**Advisory Committee Report**

**Former Moonee Ponds Market Site**

**VCAT Application for review P1634/2016 and Planning  
Permit Application MV/491/2015**

**11 April 2017**

Figure 5 Development Scenario 1 – Stage 1 and 2 ACZ1 compliant

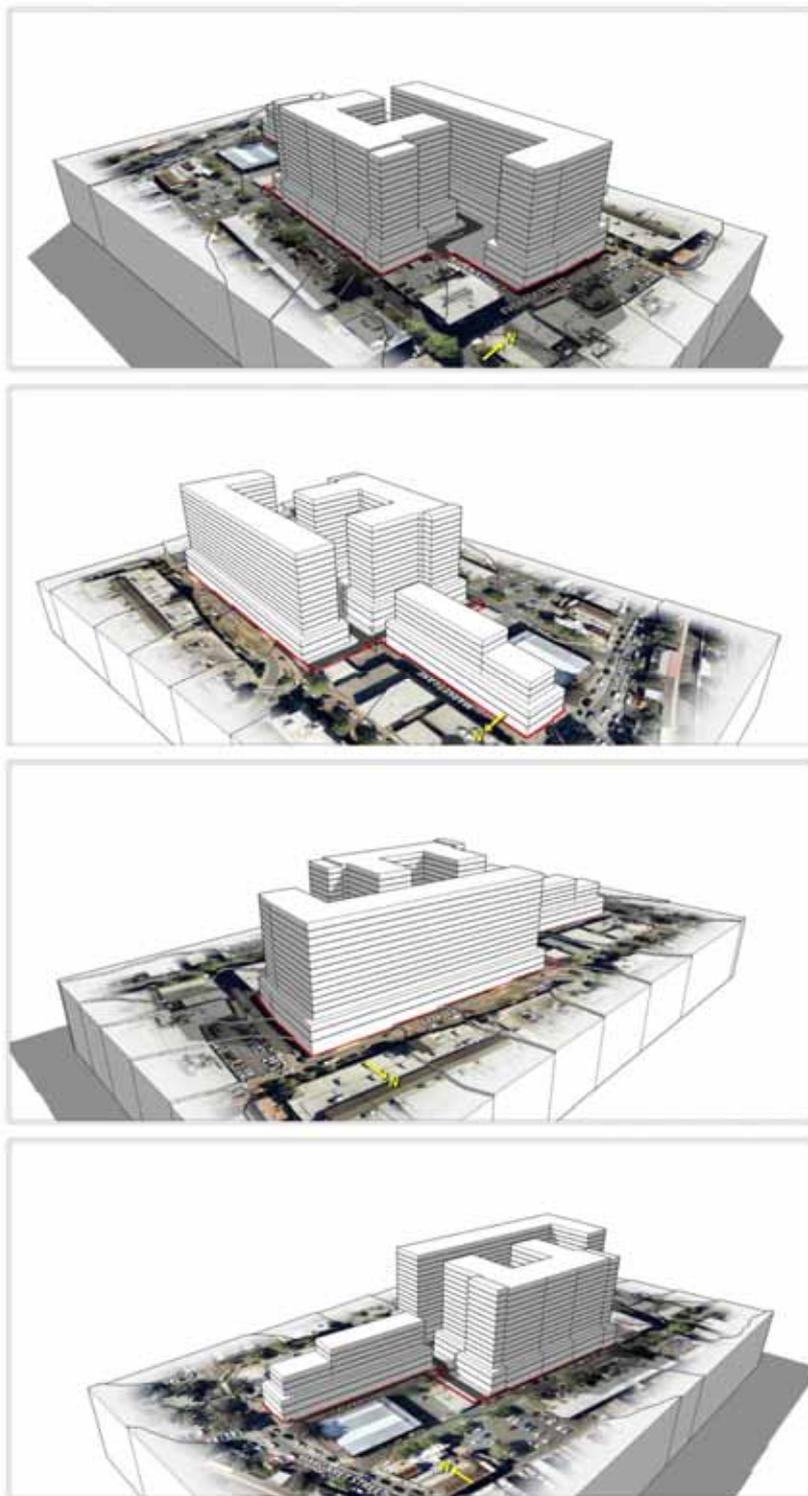
Her evidence included useful diagrammatic models which showed the site developed totally in accordance with the preferred height provisions of the ACZ1 (Figure 5), with Stage 1 as approved and Stage 2 in accordance with the preferred height provisions of the ACZ1 (Figure 6) and as proposed (Figure 7).

Figure 7 Development Scenario 3 – Stage 1 as approved and Stage 2 as proposed

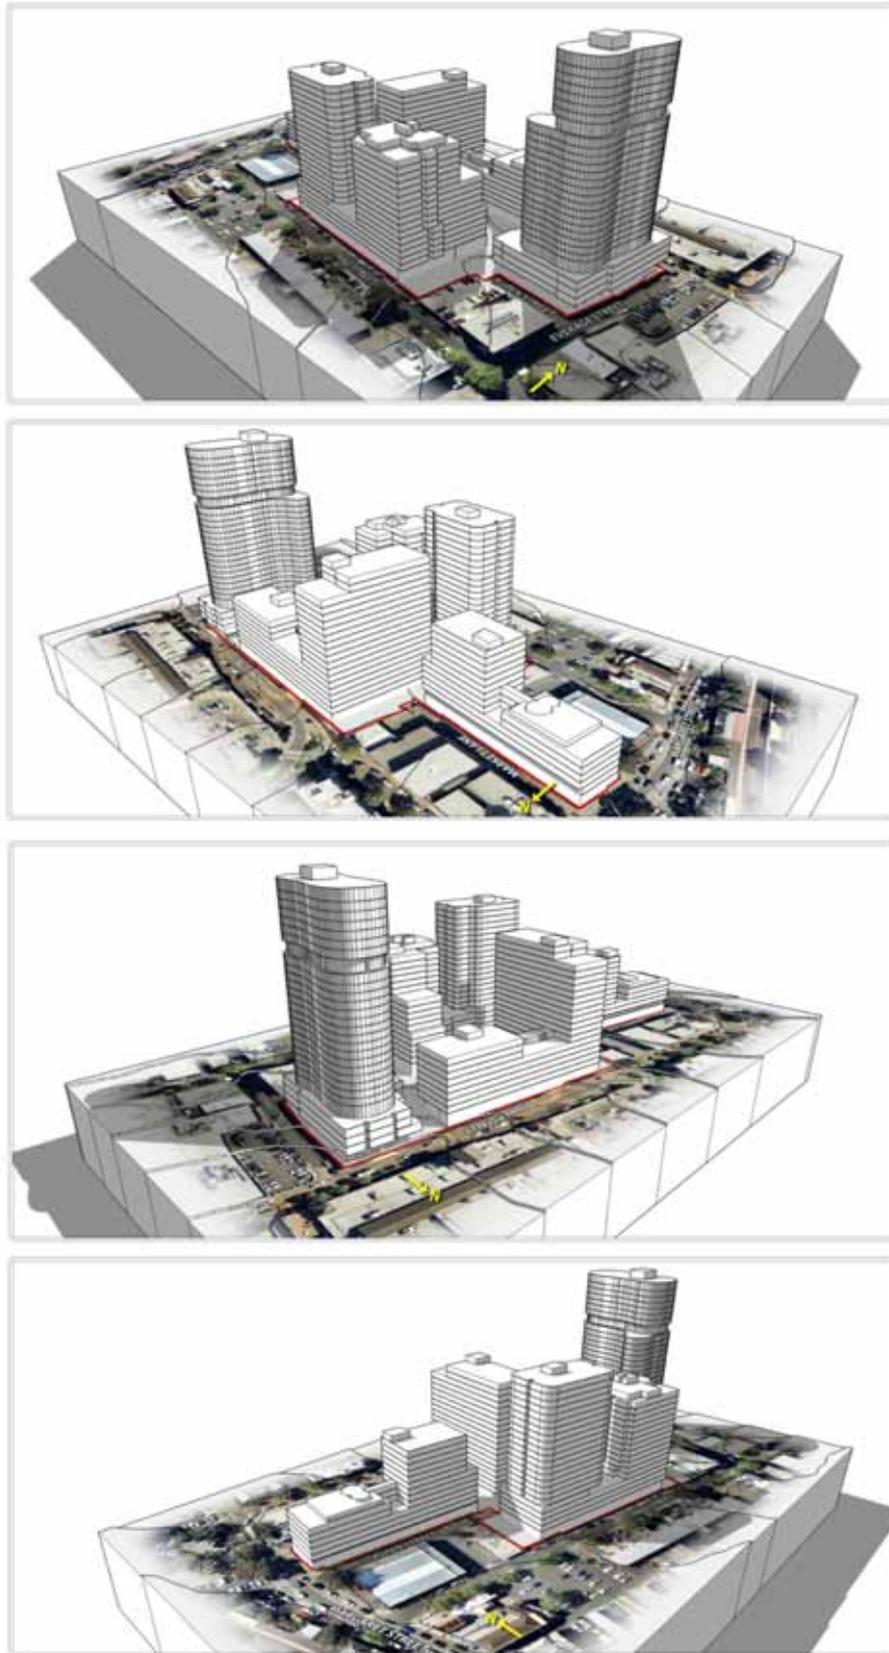
In response to cross-examination, she indicated that focussing on the preferred height limits of ACZ1 was hardly warranted given the previous agreement of Council to allow 23 storeys of development in Stage 1.

Figure 8 Northern elevation of proposed form in relation to preferred maximum 50 metre height

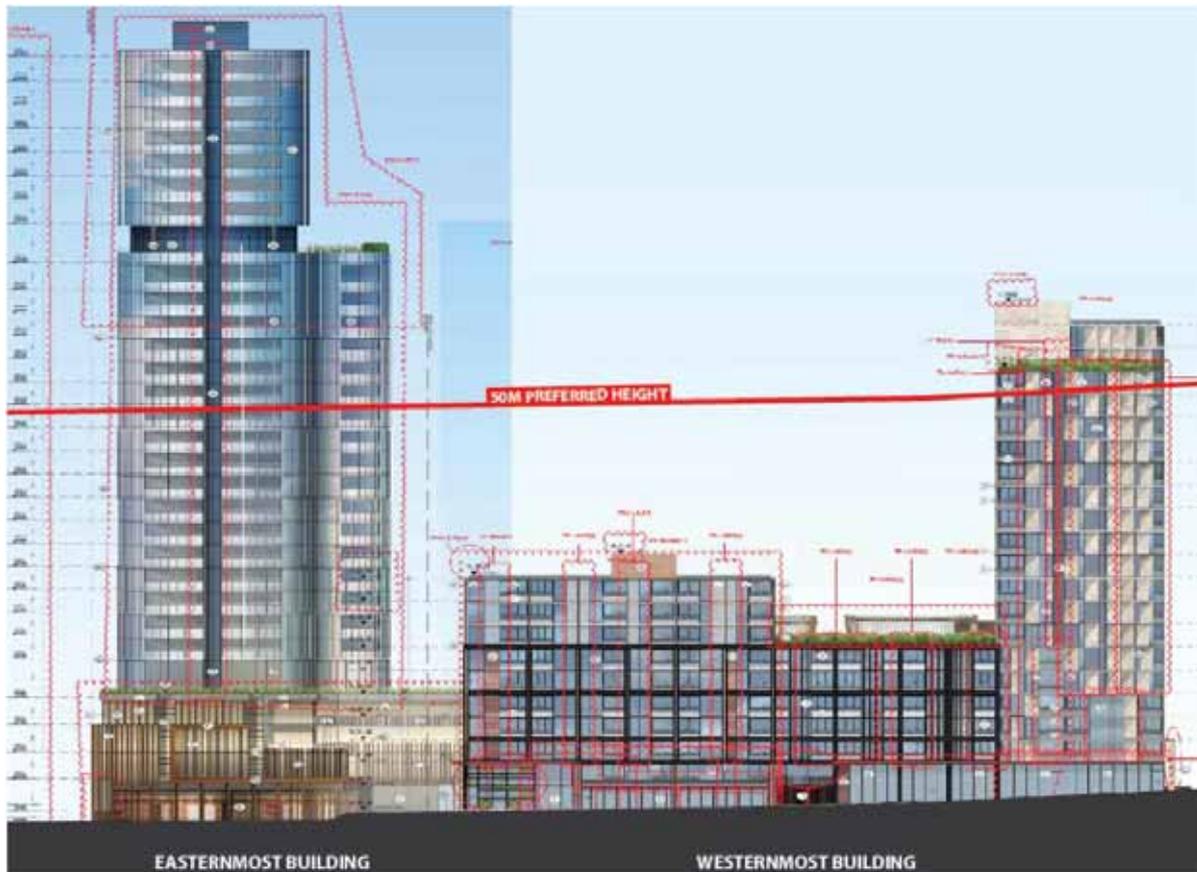
In his evidence, he provided a diagram showing the northern elevation of the proposal with the 50 metre preferred height shown as a line. This is shown in Figure 8 below.

Under questioning from the Committee, he agreed that the proposed Everage Street tower would become a landmark and dominant form on the Moonee Ponds hill and in his mind this was a good result.
